TECHNICAL INFORMATION

No: 76/01/03/NAS
Ref:
Issue: 1
Date: 01/17/03

Water Ingress at Rear of Vehicle

Discovery Series II (LT)

Figure 1

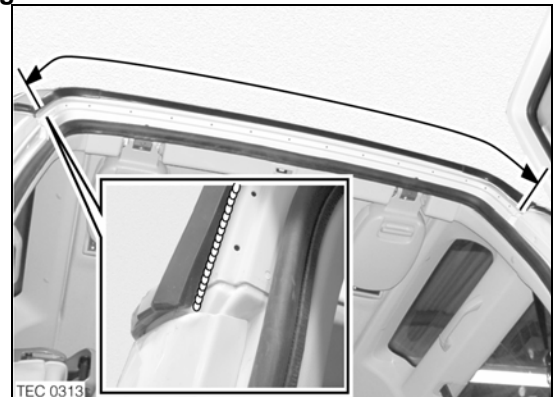
A sealing operation between the roof and the rear header outer joint may have been inadvertently omitted during production. The lack of sealant in the joint can permit water ingress.

1. Open the tail door.
2. Release 17 clips securing the tail door opening secondary seal to the body.
3. Remove the seal.
4. Clean between the roof and the rear header outer joint (Figure 1).
5. Apply a continuous bead of sealant between the roof and the rear header outer joint (Inset in Figure 1).
6. Wipe off any excess sealant.
7. Fit and secure the tail door opening secondary seal to the body.
8. Close the tail door.
